INDESIT company

W642TXEX(BG)

F027940

General notes

FIG. 1

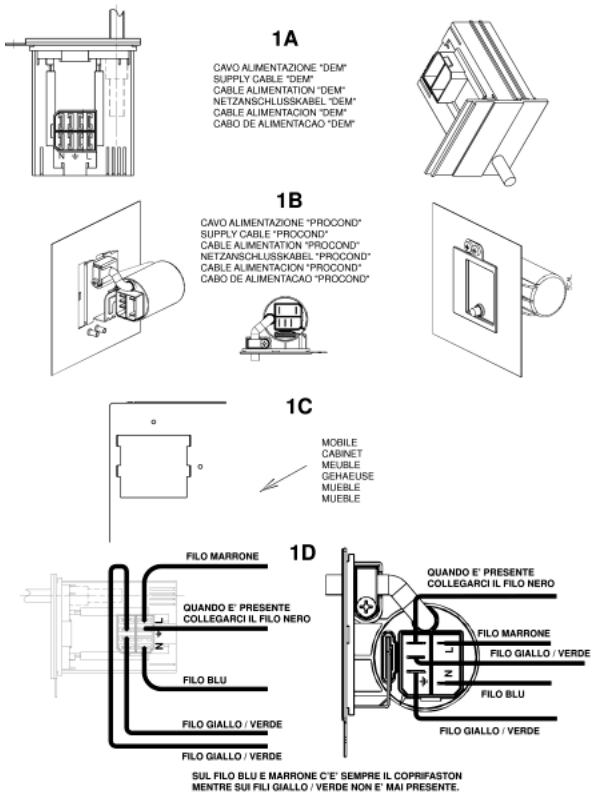
n1040276: Power supply cable + integrally moulded filter.

All appliances produced in the Comunanza (from serial no. 21008.0001), Teverola (from serial no. 21111.0001) and Brembate (from serial no. 21119.0001) factories have been equipped with power supply cables with integrally moulded filter (see fig.1 - 1A and 1B) and new units having a specific opening at the back for fixing the new cables (see fig. 1 - 1C).
The new units, together with the new cables, can be used in place of the premodification ones, by connecting the wiring to the cable, as shown in figure 1 - 1D.
The codes of the new units and of those replaced (ESI - table n1040276fig02), which will be managed until stocks run out, are given below.

IMPORTANT: the fixing / continuity screw is a specific self-scraping screw (code 092348) that ensures earth continuity between the filter and the unit. The same screw must be refitted in order to guarantee machine conformity.

The premodification wirings, are also managed for modified products by making the connection to the terminal block of the new cable as shown in fig. 1 - 1D.
The wiring diagrams given in the Documentation remain unchanged.

The new power supply cables are:
Code 091632 - Power supply cable 3x1 schuko 1.5m+capacitance filter;
Code 091633 - Power supply cable 3x1 schuko 1.5m+inductive filter;
Code 091634 - Power supply cable UK 3x1 l= 1950mm + inductive filter;
Code 091635 - Power supply cable UK 3x1 l=1950mm+capacitance filter;
Code 091636 - Power supply cable l=2.55m AUS+inductive filter;
Code 091641 - Power supply cable l=2550mm AG +capacitance filter;
Code 091642 - Power supply cable 1.85mt SHUKO no inductive filter;
Code 091643 - Power supply cable 3x1 (CH) 1.5m+inductive filter;
Code 091645 - Power supply cable 3450mm SOUTH AF.+capacitance filter;
Code 091690 - Power supply cable shuko l2.55m KOREA+inductive filter;
Code 091689 - Power Supply cable l=2550mm AG+inductive filter.

n1040277: Modification of pressure switch protection and tube

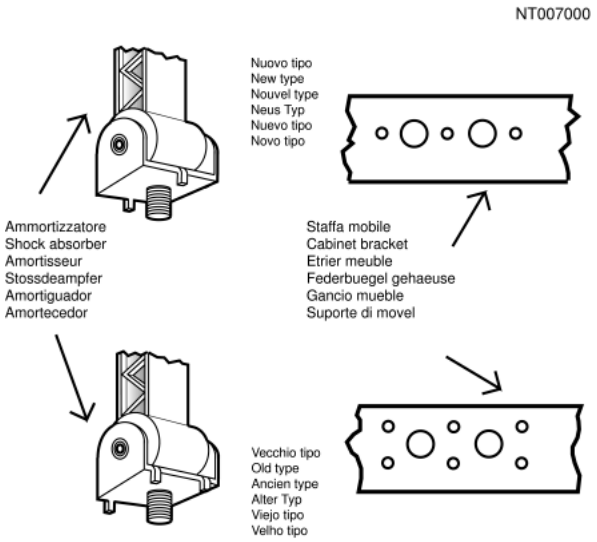
From serial no. 21104.0001, all washing machine models produced in the Brembate factory and relevant to this note have been equipped with a new pressure switch tube 041785 replacing 051552, a new pressure switch tube protection 019755 replacing

078221 and two plastic clamps replacing terminals 051541.
premodification parts will be managed until stocks run out and are interchangeable with the new ones only if used altogether.

n1040298: Modification of s/steel tubs - dispensers - detergent loading tubes on Brembate

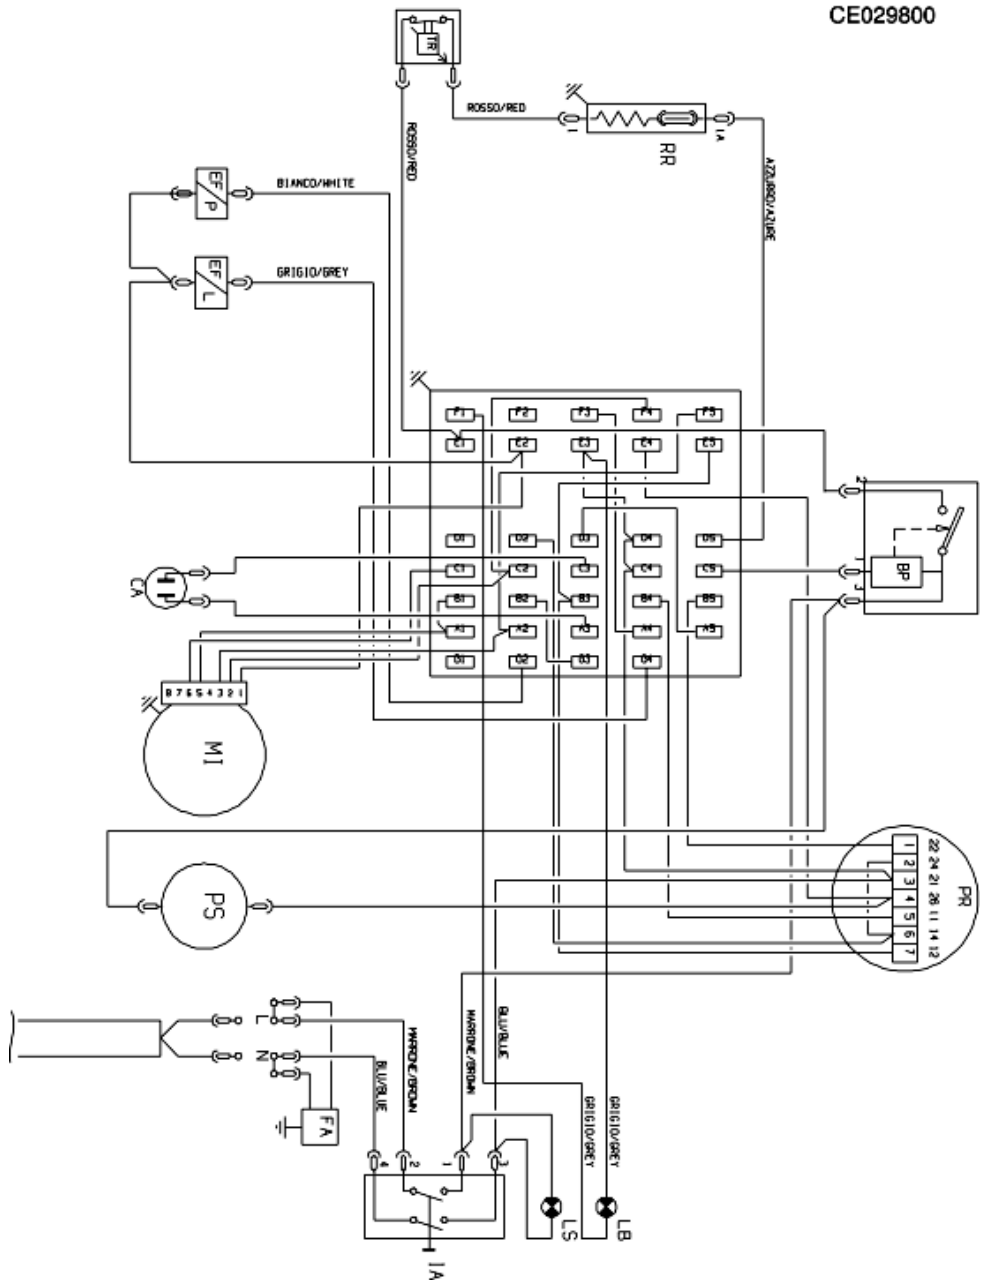
From serial number 30609.0001, all washing machines produced in the Brembate factory and affected by this note have been equipped with the new EVO2 detergent loading tube; the modification has also involved the tub (the detergent loading tube hole has been shifted forward) and dispenser.
The Sat codes of the new parts and the premodification items are given below:
DETERGENT LOADING TUBE (two instead of three):

-new 092161, premodification 064528;
-new 092273, premodification 080654;
-new 092161, premodification 074136;
DISPENSERS:
-for linear detergent drawer: new 092314, premodification 075351;
-for rotating detergent rotary drawer: new 092176, premodification 064529;
TUBS:
-new 095717, premodification 090589;
-new 095718, premodification 090934;
-new 095720, premodification 090206;
-new 095721, premodification 090321;
-new 095722, premodification 091050;
-new 095723, premodification 090588;
-new 095724, premodification 088402.
Regarding the detergent loading tubes and dispensers, the new and premodification parts will continue to be used.
The premodification tubs will be managed until stocks run out, after which, when a tub needs replacing on appliances prior to serial number 30609.0001, the new tub plus the new detergent loading tube and new dispenser must be used (refer to the replacement parts list for the relevant model).
